16-20 Red Lion Street

Appendix to Design and Access Statement

The following document outlines the amendments made to the original planning application to address the key points raised by the Camden Planning team, BCAAC and the neighbouring building on Red Lion Street. The document is split as follows:

1 Planning - AXO - 6th floor section
Scale:

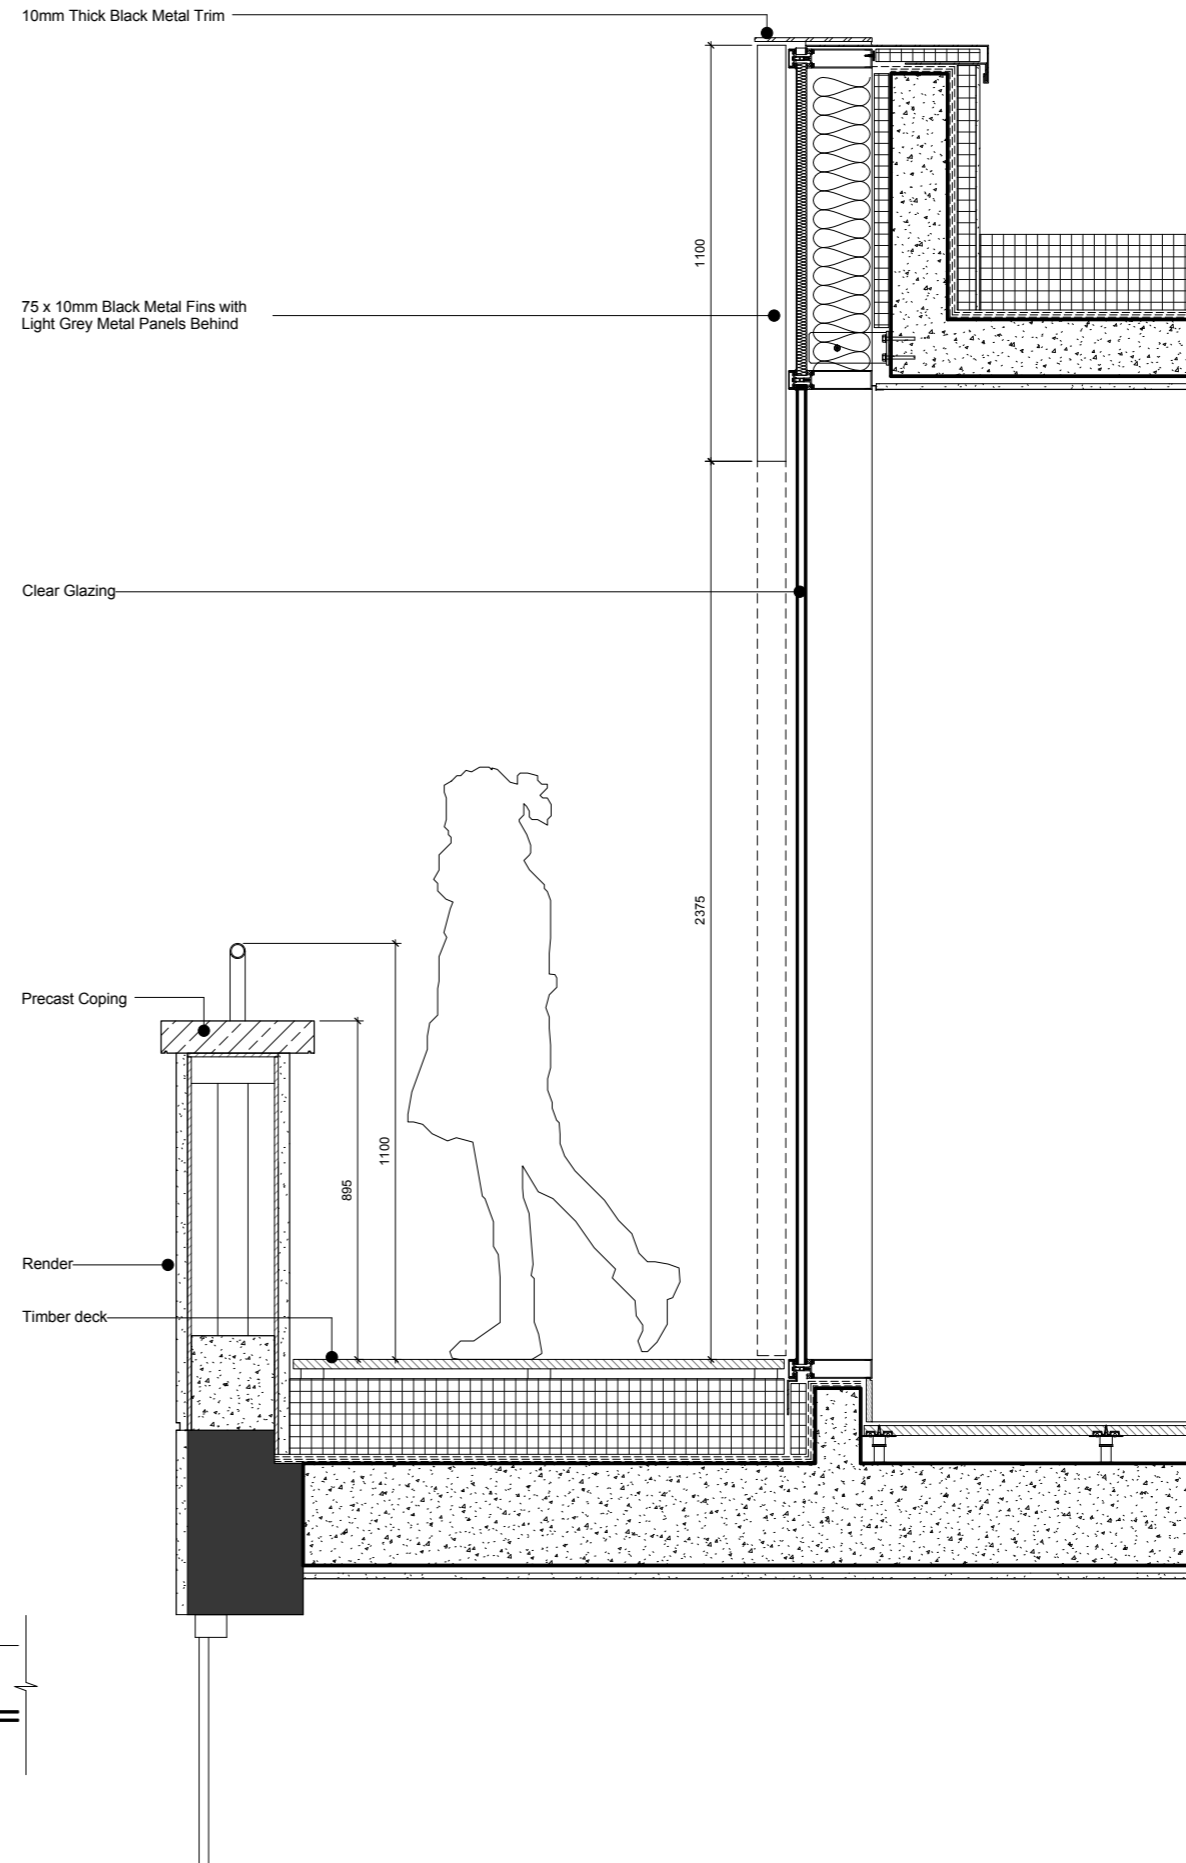
The gradual stepped approach to the roof extension and roof top plant is not supported and is considered to disrupt and further confuse the clarity of the building's design, and is considered to be a harmful addition to the streetscene. The approach of following the design and materials of the existing top 2 storeys within the proposed roof extension is not considered to be the right approach in this instance.

It is considered that the roof-top plant should not be expressed as a separate element to the extension. Strong preference was given to it being incorporated within the floorspace of the single storey roof extension, but I understand from our conversation on Tuesday that this would take up most of the area and it is therefore not feasible. An alternative solution could be for the form of the proposed extension to be redesigned to incorporate the plant so that the extension reads more confidently as a single, high quality, element. It is also requested that a different material treatment to the proposed roof extension should be explored, to differentiate appearance of the roof extension from the top two storeys that currently finish the existing building. Careful consideration should be given to the colour and texture of materials to ensure that it sits well within its context.'

- The rooftop plant has been lowered by a storey to sit within the top floor extension.
- The parapet on the 4th floor has been built up to complete the main body of the building
- The proposed extension has been remodelled to align with the proposed architecture of the repositioned ground floor entrance.
- Vertical metal fins disguise the plantroom and visually ties into the proposed ground floor entrance
